TOWN OF WELLS, MAINE PLANNING BOARD

Meeting Agenda
Monday, April 6, 2026, 7:00 PM
Littlefield Meeting Room, Town Hall
208 Sanford Road

SCALE: 1" = 20'
DATE: 11/18/25
JOB NO: C031-20
FILE: FIELD SIDE BASE.DWG
SHEET: 4

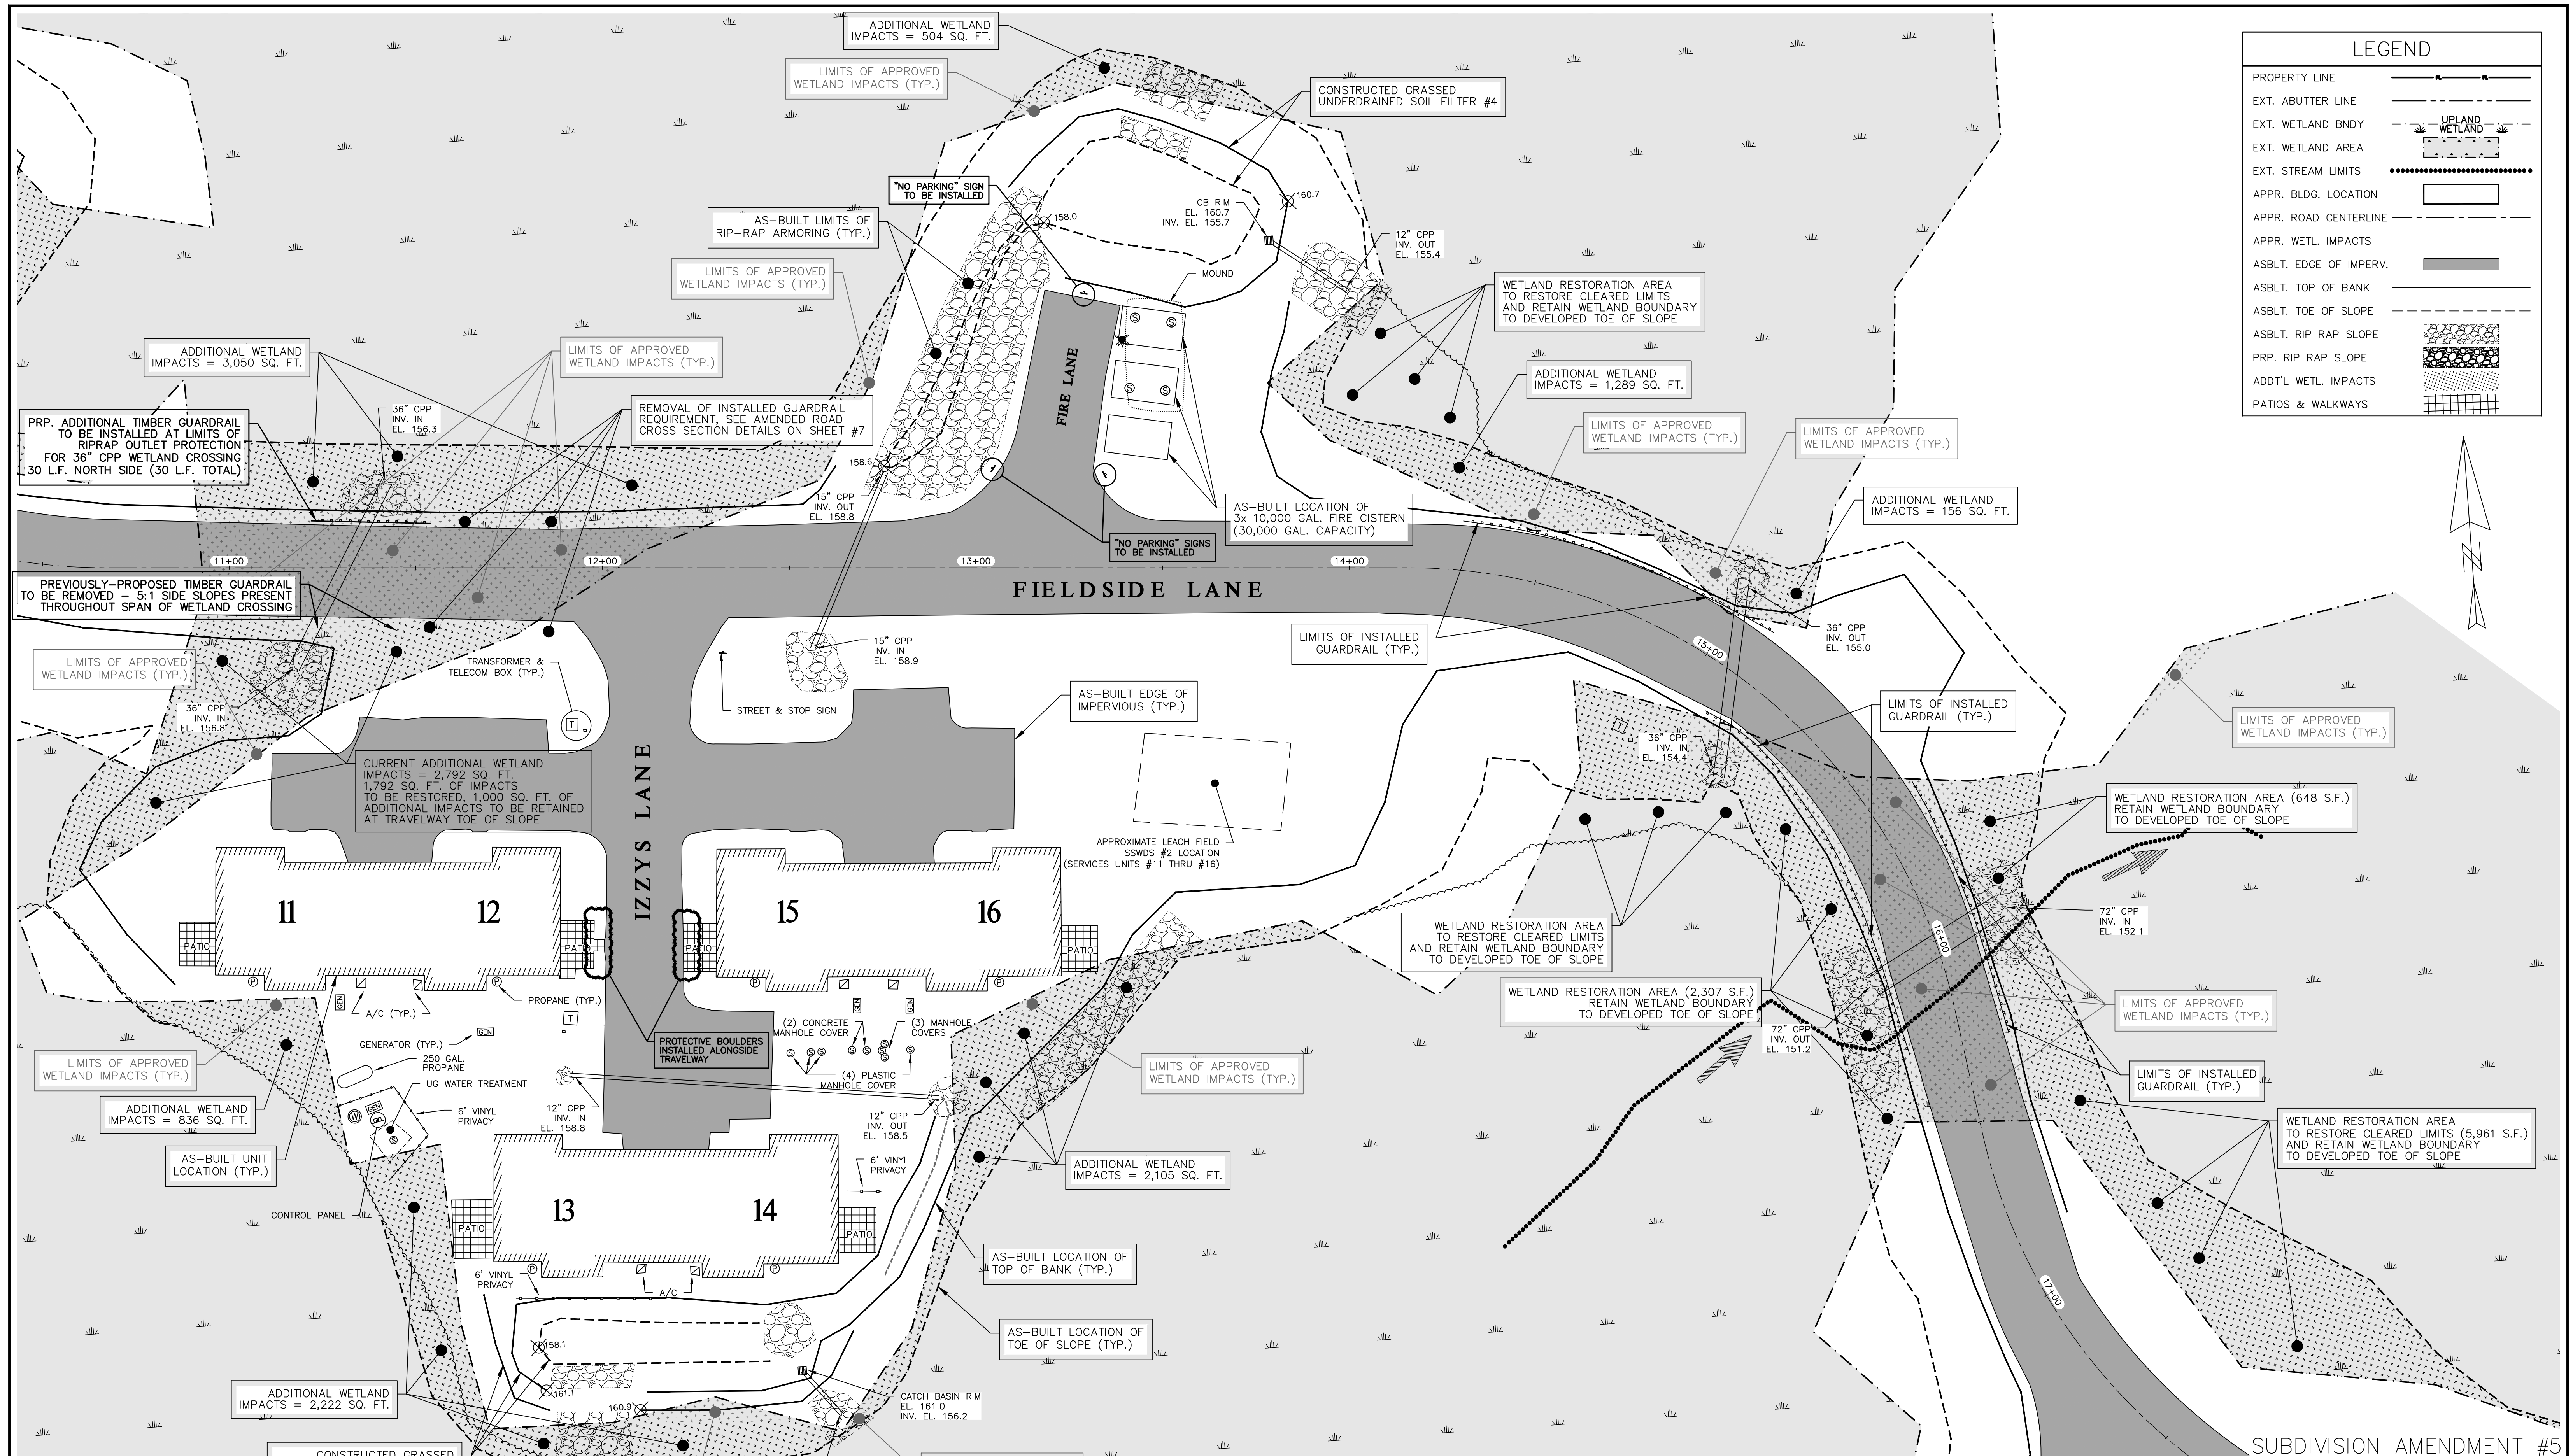
Carrying these requested changes through the Plan Set, the only resulting change is to Sheet #4 where “No Parking” Signage has been added along the perimeter of the Fire Cistern turnout to satisfy the markings that were depicted with the original approvals.

- Sheet #4 (As-Built Infrastructure Plan Pt.2) has been revised to include the areas of protective boulders that have been installed along both shoulders of Izzys Lane in the vicinity of the Unit #12 and Unit #15 Patios. Site Photos of these installed boulders are attached to the end of this cover letter.

- Sheet #4 has been revised to update the as-built conditions of the Fieldside Lane side slopes west of its intersection with Izzys Lane in the vicinity of the 36" CPP Wetland Crossing. These updates are with respect to the original approvals which called for steeper side slopes and timber guardrail to be installed for the wetland crossing span. Shallower (5:1) side slopes allow the majority of this guardrail to need not be installed, with the remaining required guardrail be up-slope of the riprap outlet protection for the 36" CPP Wetland Crossing. A 30 linear foot span of timber guardrail has been added to be installed on the downstream side of this crossing. Callouts have also been added to reference amended Road Cross Section Details, which shall be discussed below. Site Photos of these side slope spans are also attached to the end of this cover letter.

JOB NO: C031-20 FILE: FIELDSIDE BASE.DWG SHEET: 6

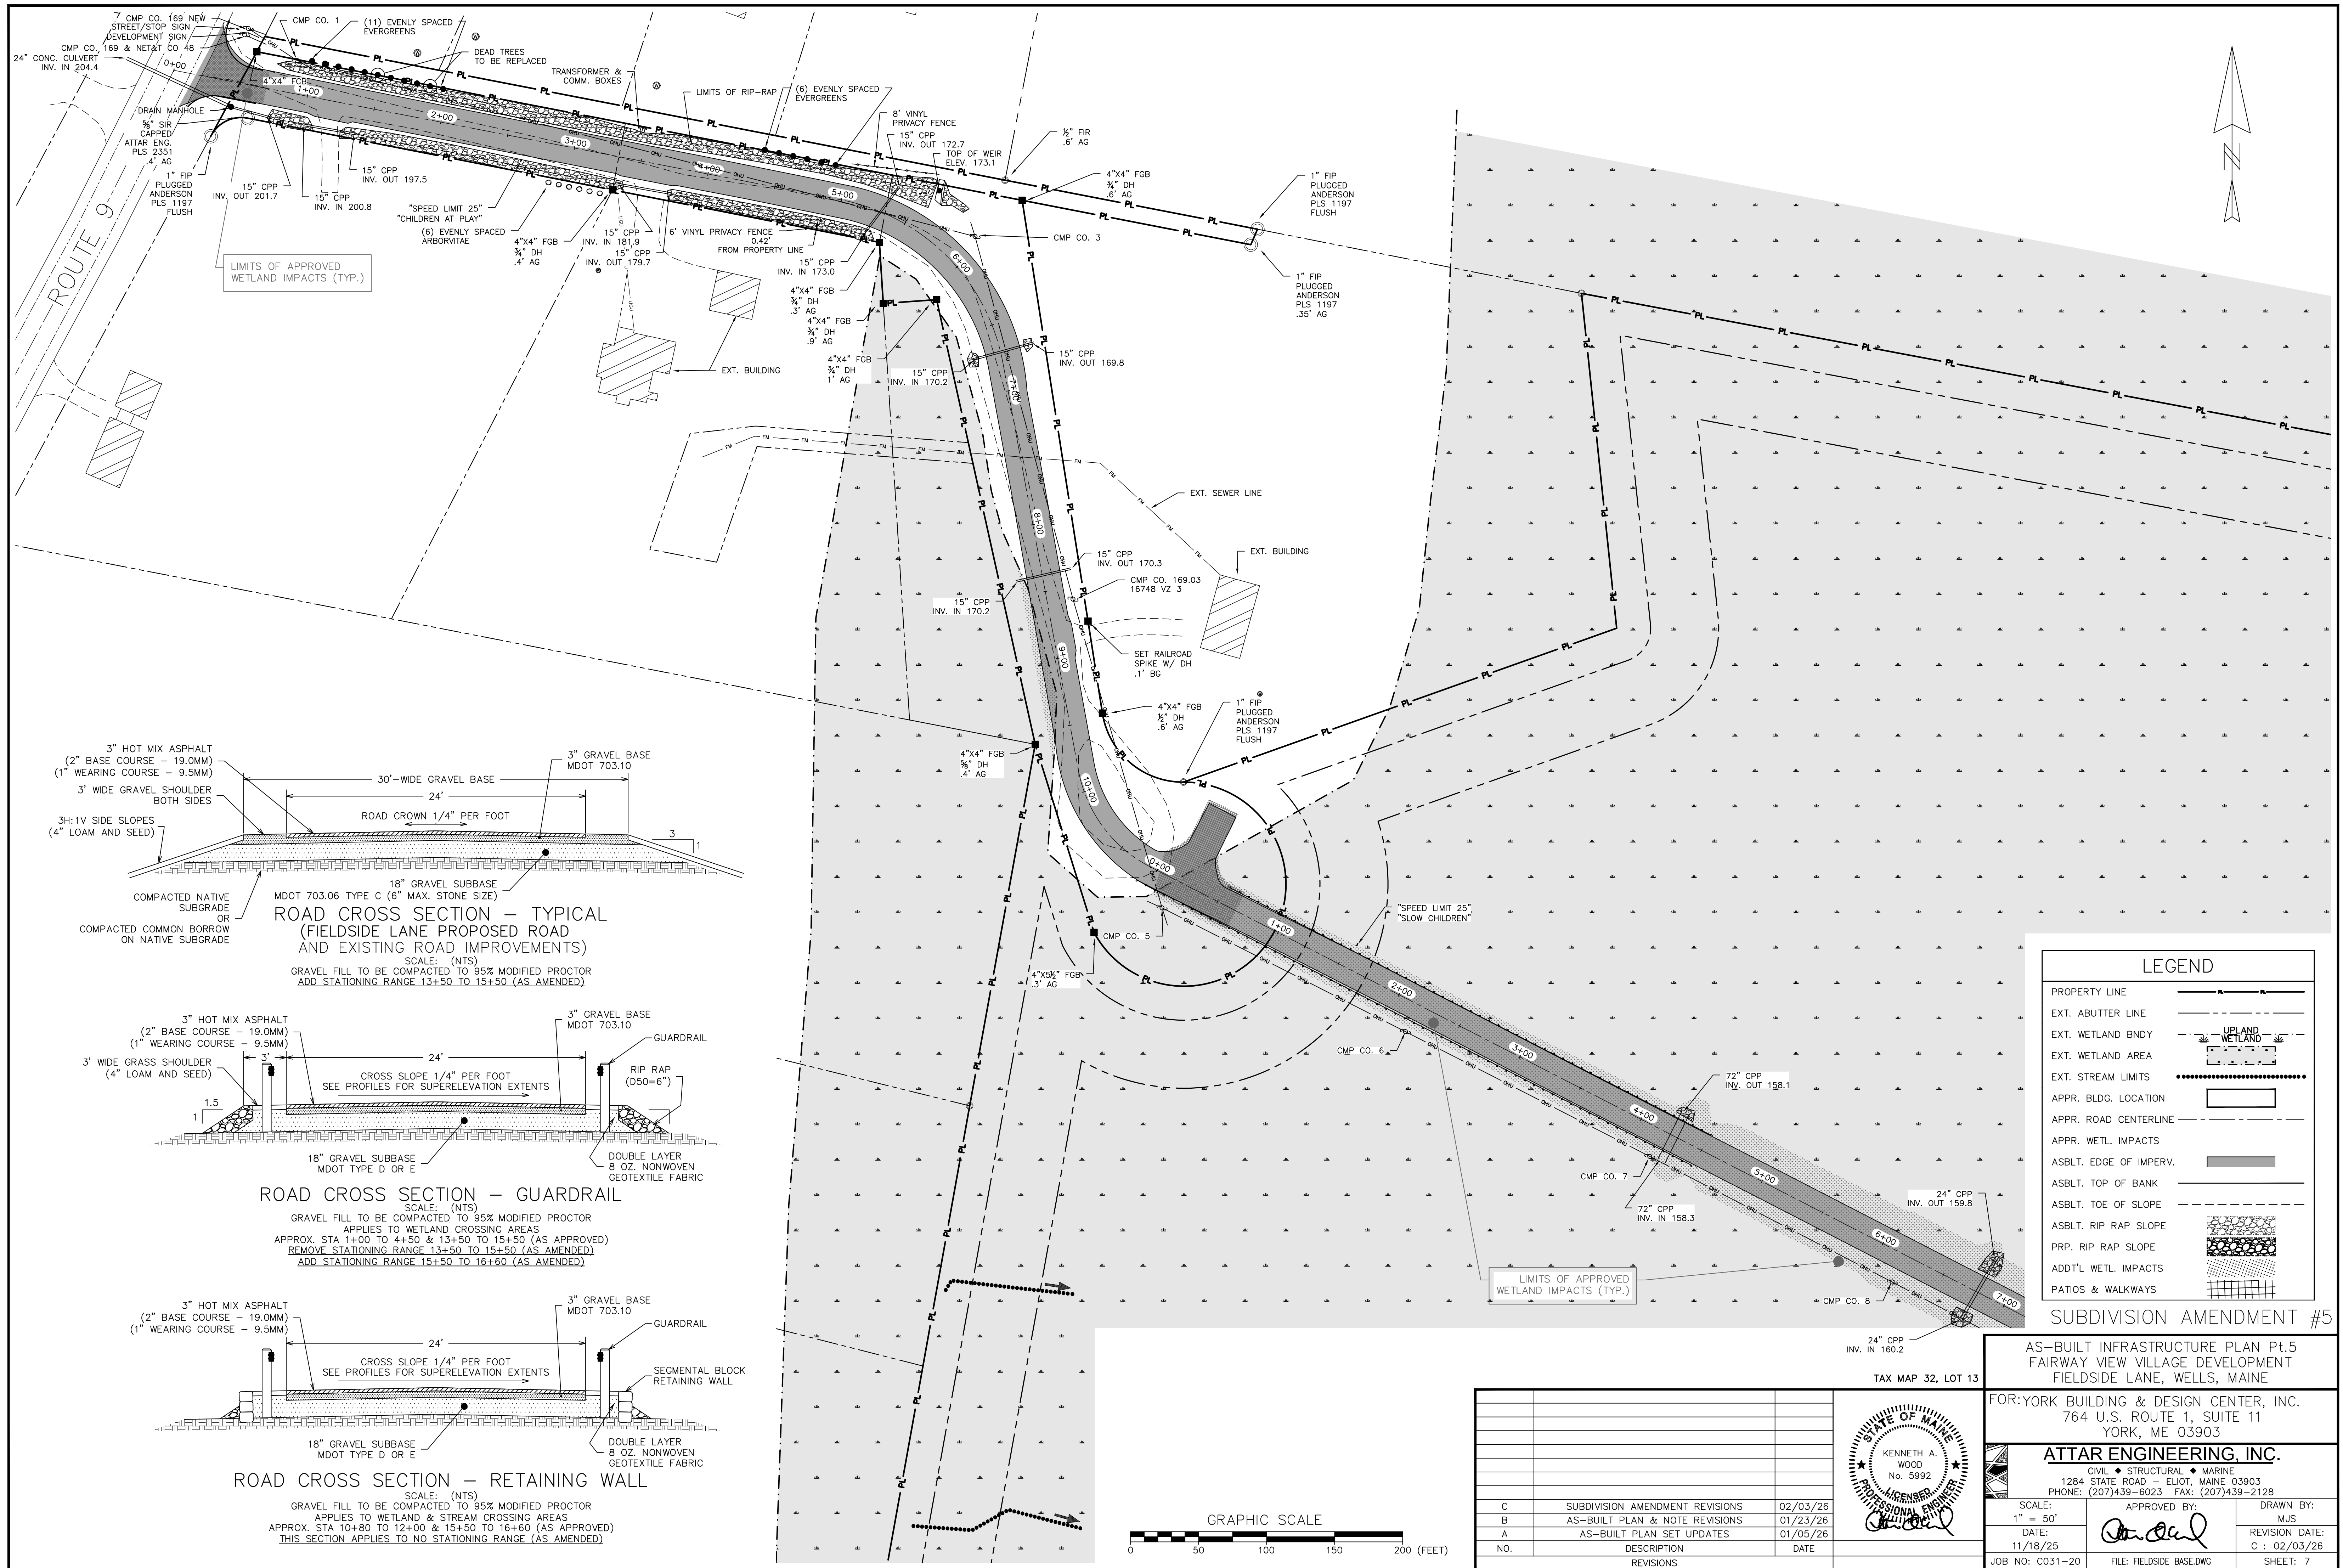
3. Preliminary Review Comments:
 - a. Note changes to be reviewed, some revisions needed.
 - b. Revised drainage calculations to be reviewed.
 - c. As-built plan markups provided in February 2026 not addressed.
 - d. Guard rail eliminations are contingent on MDEP/ ACOE approvals.
 - e. Limit of existing finish course of pavement to be depicted on sheet 6.
